Service Bulletin

Bulletin No: JC-019-12

Product Type: STEINER 440

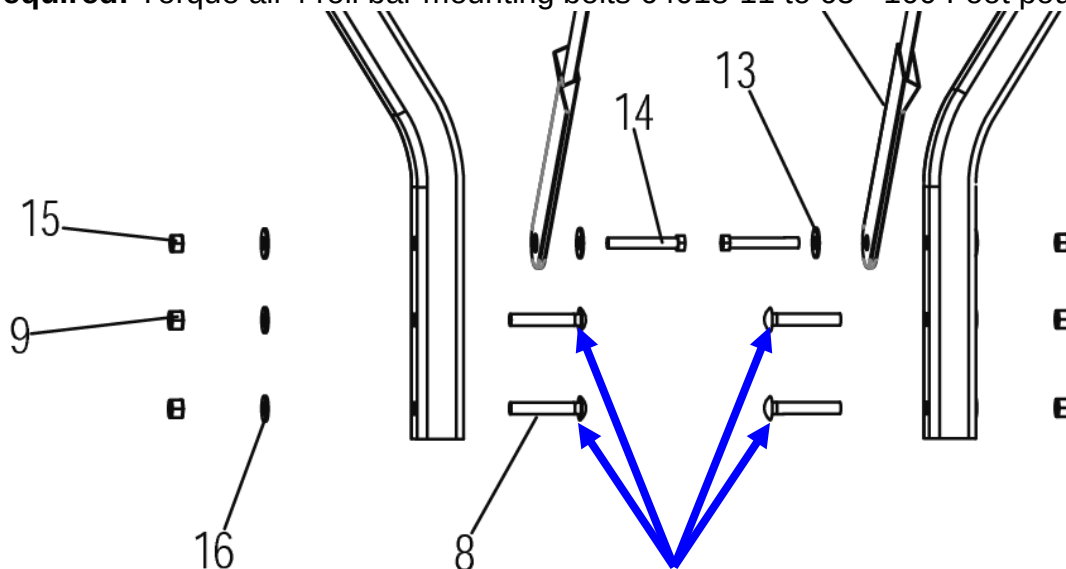
Customer Issue: Roll-over Protective Structure (ROPS) can move back and forth on the frame.

Cause: The 4 mounting bolts to the frame are not tightened properly in assembly.

Action required: Torque all 4 roll bar mounting bolts 64018-11 to 65 - 100 Foot pounds
